Memo

To: Alan Goldich, Senior Planner
From: Kyle P. Collins
cc: Kristy Wisner, Planning Director
John Vanderbloemen, Esq.
Date: October 13, 2024
Re: PL20240059, Special Use Permit, SMR - SUP # PP2006—005 Amendment

Blow up of Location 5 on page 4 of the Visual Impact Analysis submitted.

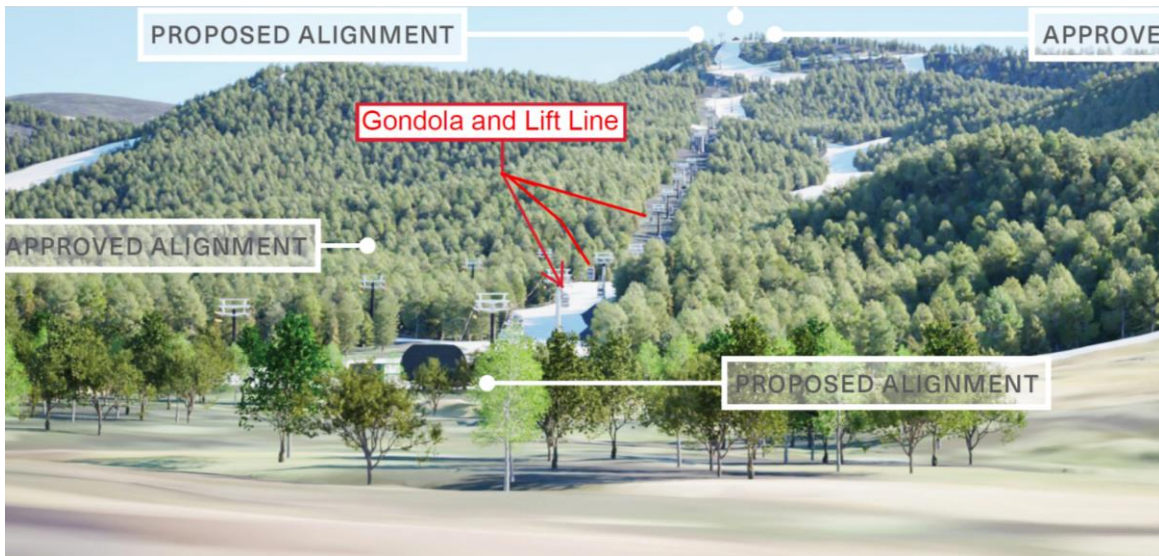
3.37 Mitigation Techniques to Reduce Impacts to Scenic Quality

The ski lift has been designed utilizing low profile towers ranging in height from 16.6 feet to 63.12 feet, with an average height of approximately 46 feet, which is less the height of the canopy associated with the mix of conifer stands located on either side of the proposed ski lift. As outlined below the clearing proposed is the minimum necessary to install the proposed lift.

The top terminal of the proposed ski lift has been relocated from the edge of the ridge as currently approved to further back from the ridge line so it cannot be seen for lower elevations. In addition, the proposed realignment of the ski lift is now located within existing cleared areas of the mountain which resulted in a reduction the amount of clearing required by approximately ¼ of an acre.

As reflected in the Visual Impact Analysis submitted these mitigation measures have reduced the visual impacts associated with the proposed ski lift realignment.
